Re: Water Heater Ignition of Flammable Vapors

CPSC STAFF QUESTIONS AND CONCERNS
FOR DISCUSSION AT AUGUST 30, 1994 MEETING

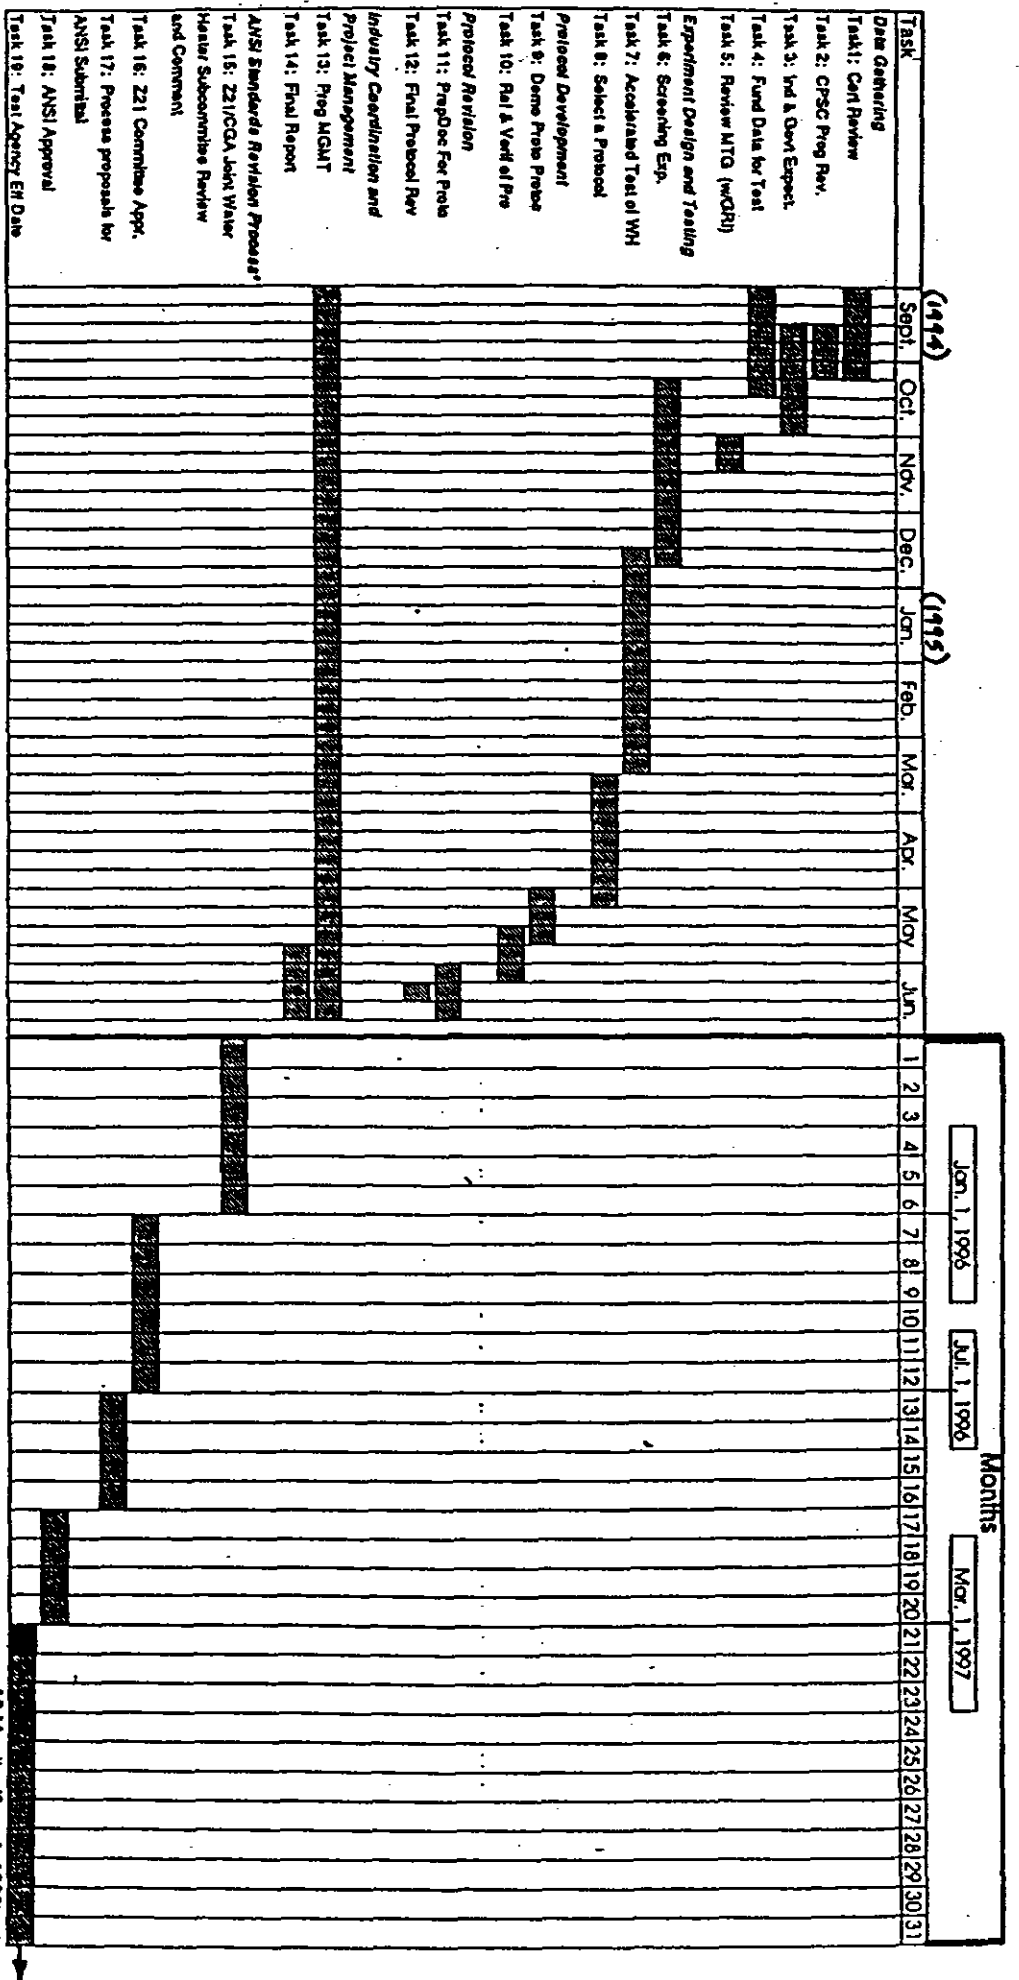
QUESTION 7. Please provide a graphic depicting all the steps, and the anticipated beginning and completion dates of each step, from initiation of the proposed Development of a Flammable Vapor Screening Protocol for Gas-Fired Water Heaters to publication and implementation of performance requirements to address this hazard.

ANSWER: See attached graph which also has supplemental notes on ANSI standards revision process attached.

NOTES ON ANSI STANDARDS REVISION PROCESS (ANSI Z21.10.1):
